FINAL PRODUCT/PROCESS CHANGE NOTIFICATION #16403

TITLE: Vreg Spec Relaxation on HSBA-005

AFFECTED CHANGE CATEGORY(S): specification change

Vreg_{offset}

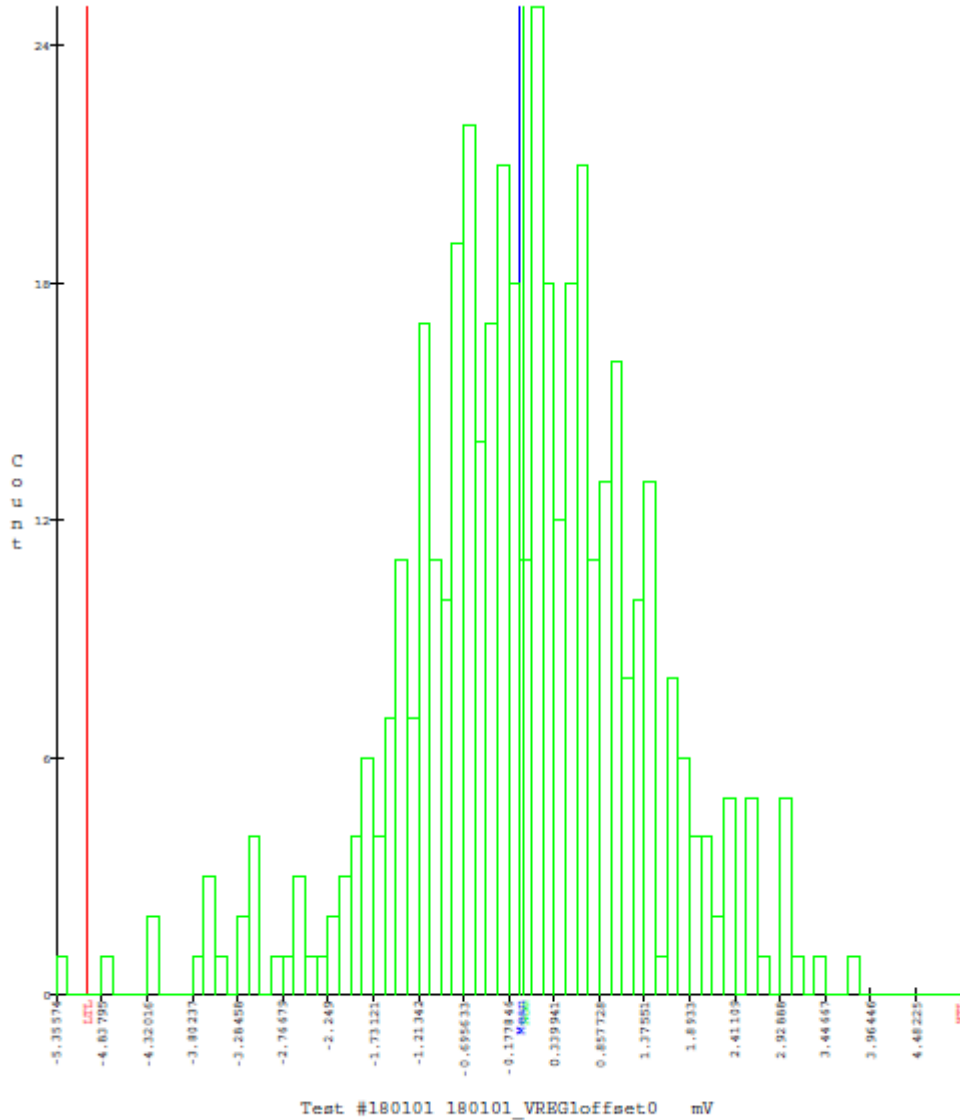
Test	Spec	Unit	Actual LSL	Actual USL	Proposed new LSL	Proposed new USL	
Vreg _{offset}	8.1	mV	-6	6	-8	8	Packaged version

The distribution is shown below (standard production data):

Mean:	-0.05073	Cp:	1.21394	Failures (PPM):	266.908
Sdev:	1.37294	Cpk:	1.20162	Deviation from the Nominal:	0.000051
Lt1:	-5	Ht1:	5	Taguchi Loss Factor:	0.075501
Pop. Size (N) of the Data Set:	436			Data is:	Not Normal

Current Cpk (spec limits) is 1,44. New cpk (new spec limits) with shifted spec window is 1,93.
